DOH Review: Navy Groundwater Flow Models & Related Issues with the Navy CSM for the Red Hill Facility

*The Department of Health Hawaii (DOH)
Technical subject matter experts
Robert Whittier, Don Thomas, G.D. Beckett
& Anay Shende*

October 19, 2021

Local Water Levels

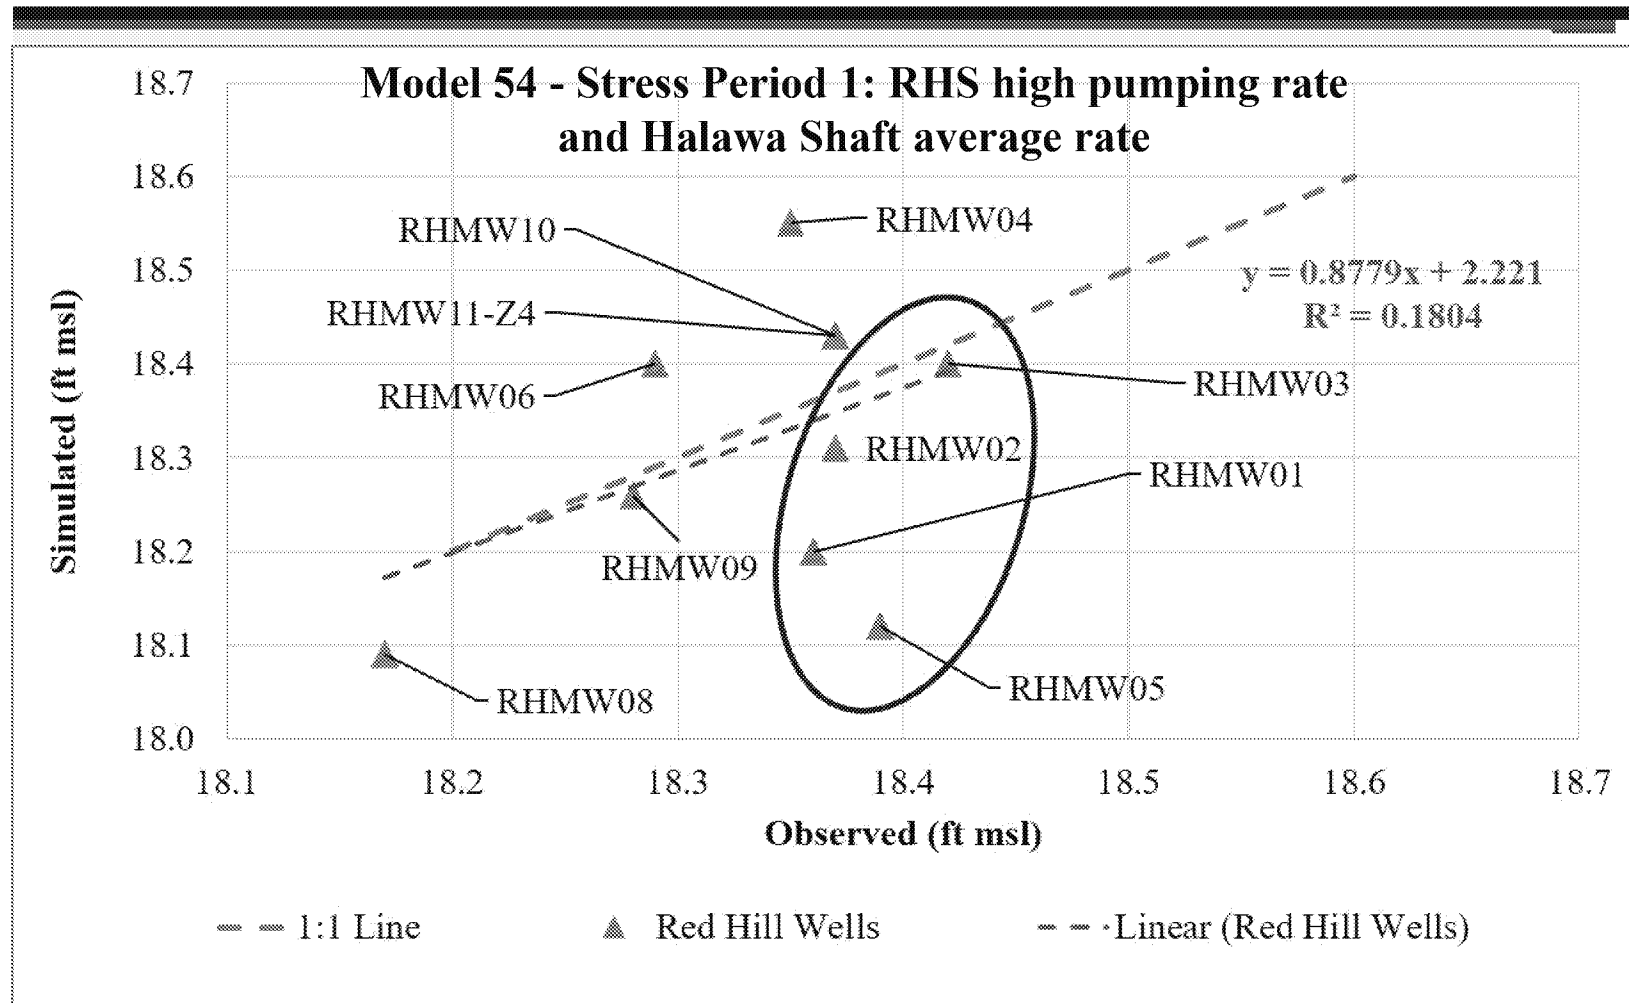
(Navy GWFMs do not match local data)

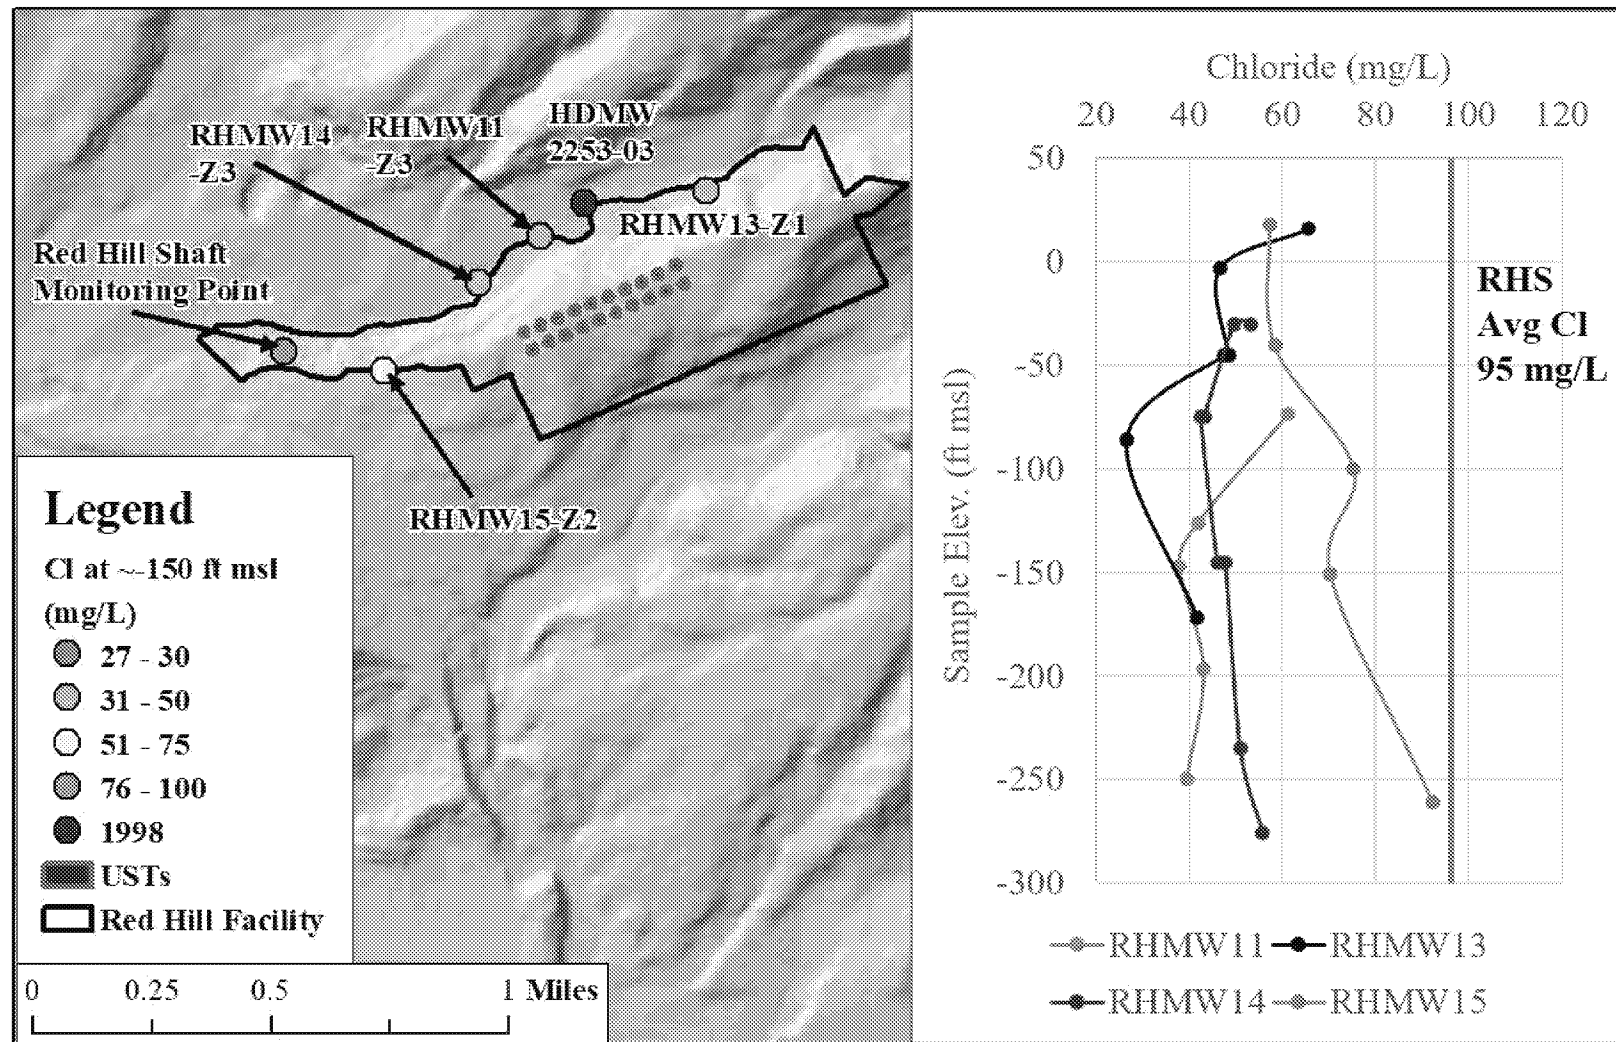
It is unlikely that chlorides originating in the Halawa region elevated the chloride concentration in the RHS

13 2.3.2 Overview of Preliminary Capture Zone Analyses

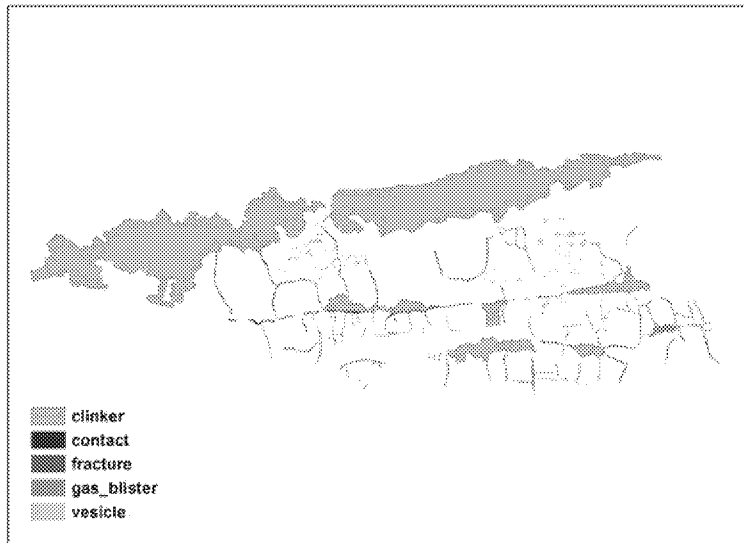
- Investigation and Remediation of Releases Report; Page 2-18
- Issues previously discussed cast doubt on the assumption the Red Hill Shaft will contain the offsite migration of any contaminant plume
- The model results are currently not informative for developing release response plans
 - Questions regarding the ability of the RHS to capture a contaminant plume and the risk the Halawa Shaft remain unanswered

Figure 5.1.1-7, Redacted GWFM Rept, Mar 2020

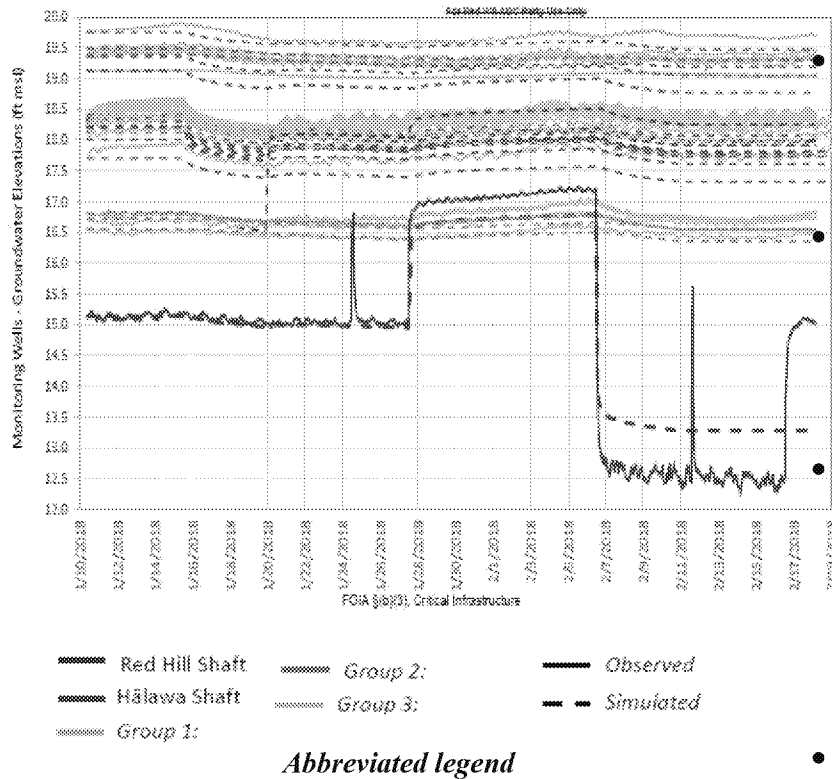
(GWFM's apparent mismatch to g.w. elevations)

Example Hydrographs; M51a Verification

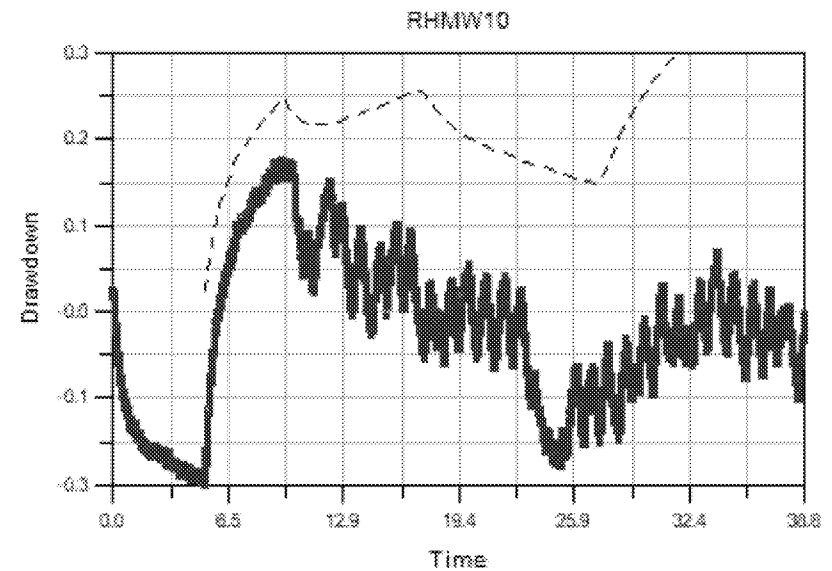
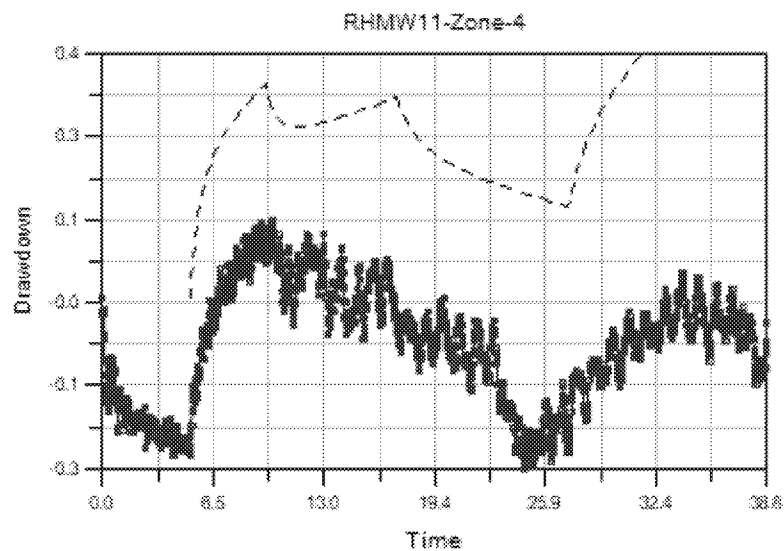
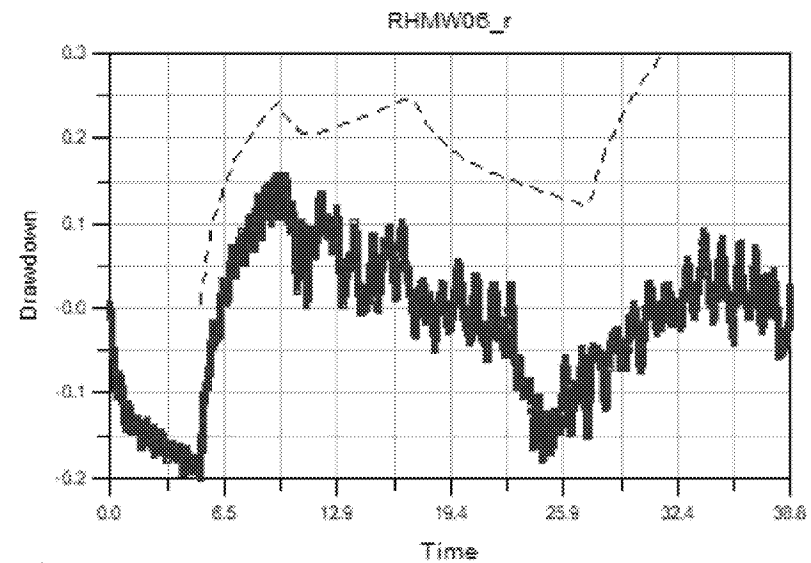
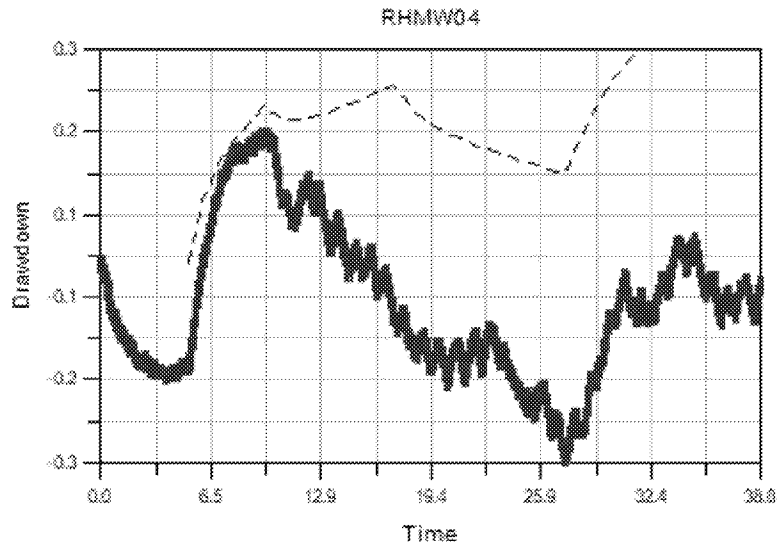
- Identify deficiencies in main models
- Identify which are “best fits”
- Consider transient implications
- Consider compartmental responses (& others)
- Issue, we cannot replicate the reported results
 - Plots do not agree with modeled output
 - May be a superposition (drawdown upon measured)
- The g.w. elevation offset was prior model issue
 - Recall primary AOC objective

Non-Uniform Distance Drawdown Behavior

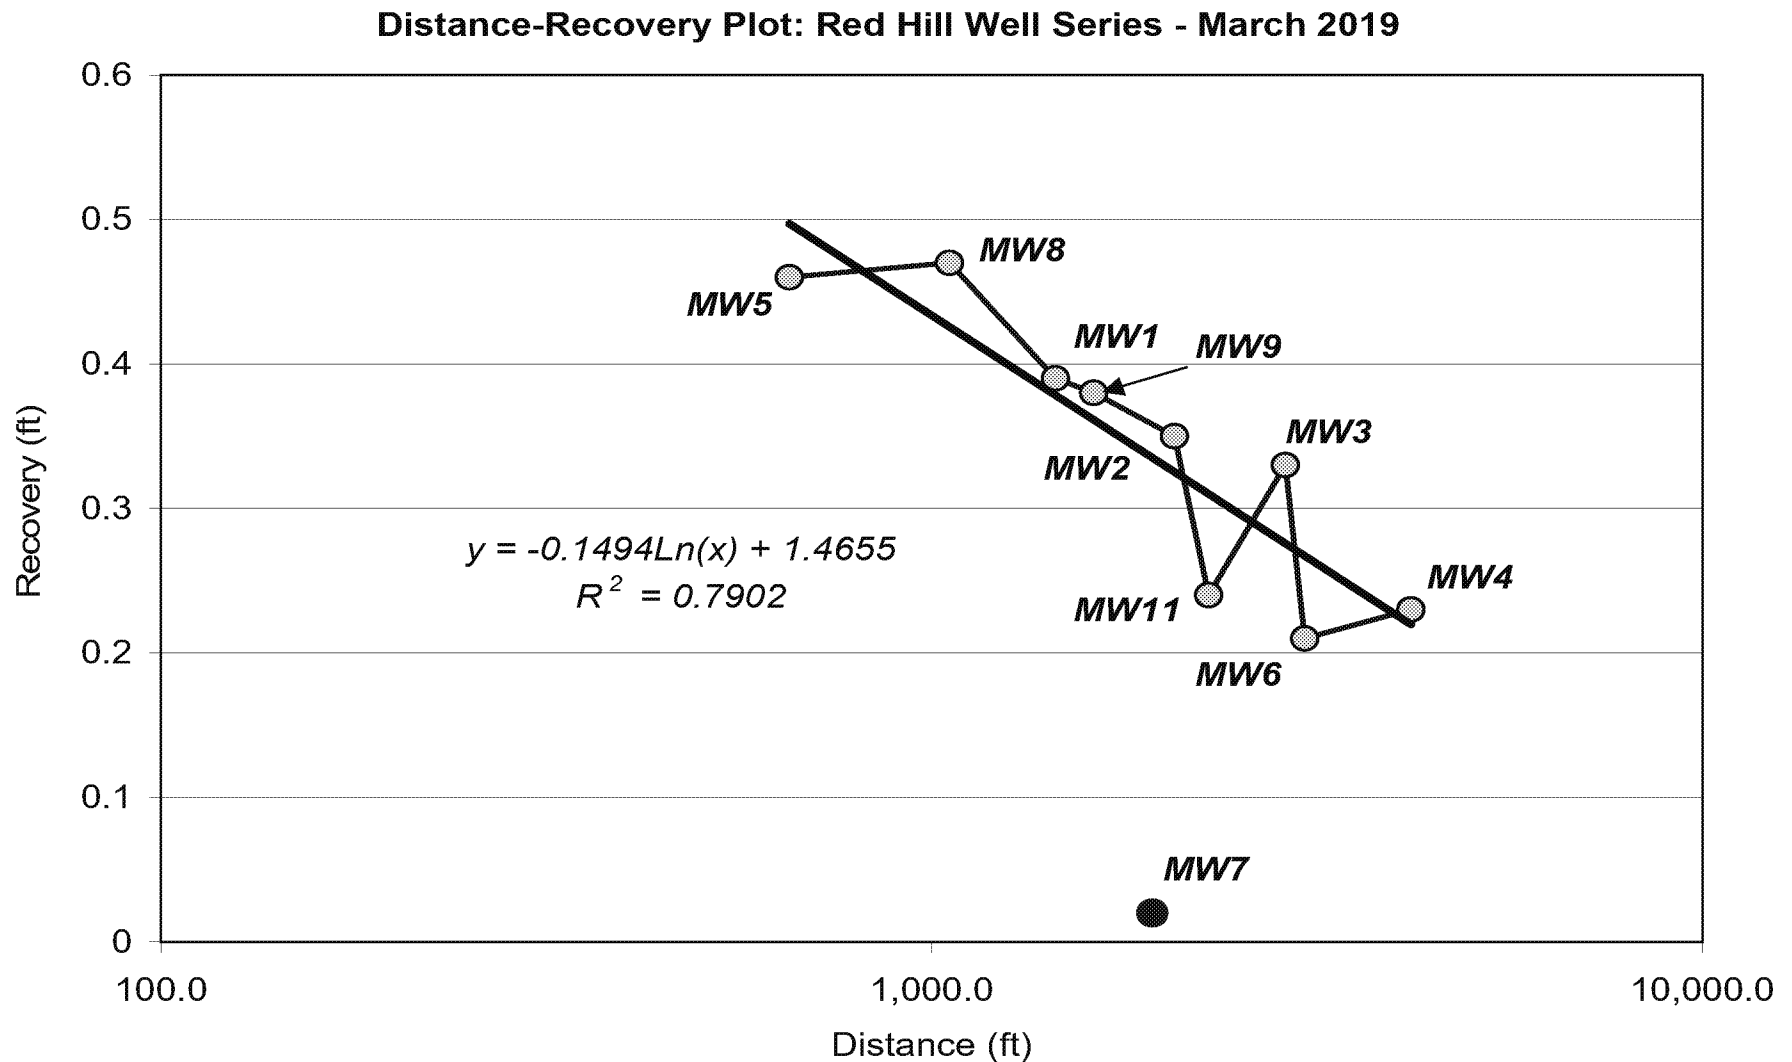
(indicates complexities not captured by models)

Example Navy CSM Cross-Section

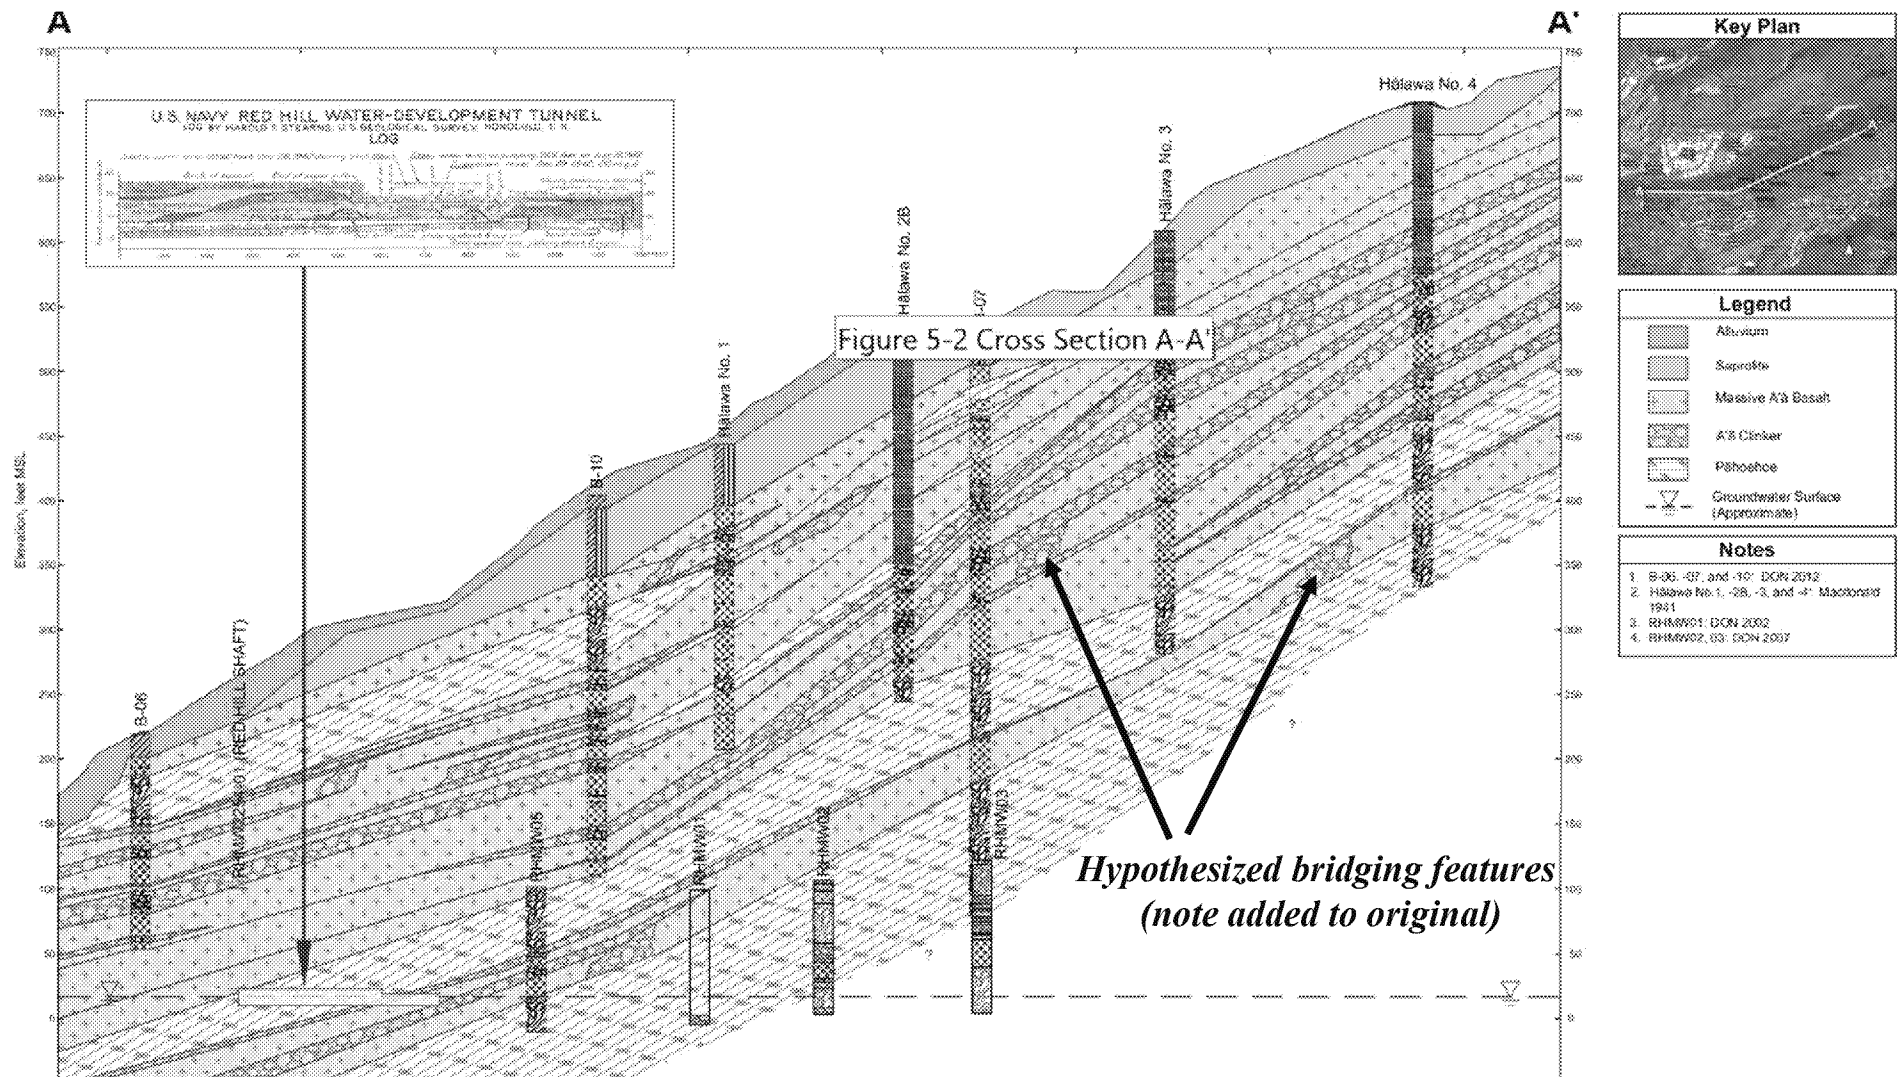
(schematic rendering, but details are not in GWFMs)
